MEMORANDUM DATE: November 2, 2022

RE: **432 South L Street**

TITLE: **HRPB Project Number 22-00100376:** Consideration of a Certificate of Appropriateness (COA) for front door replacement for a single-family house located at 432 South L Street; PCN# 38-43-44-21-15-157-0010. The subject property is a contributing resource within the Southeast Lucerne Historic District and is located in the Single Family Residential (SFR) zoning district. The future land use designation is Medium Density Residential (MDR).

Exhibit 1 – Existing Front Door

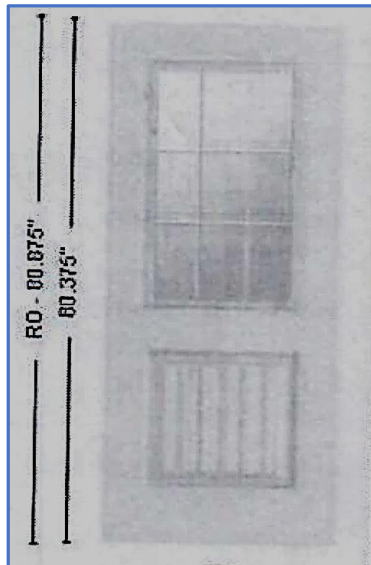
STAFF RECOMMENDATION: Staff is recommending denial of the applicant's proposed replacement door, as its panel design is more appropriate for a Mission or Mediterranean Revival style building rather than a Wood Frame Vernacular building.
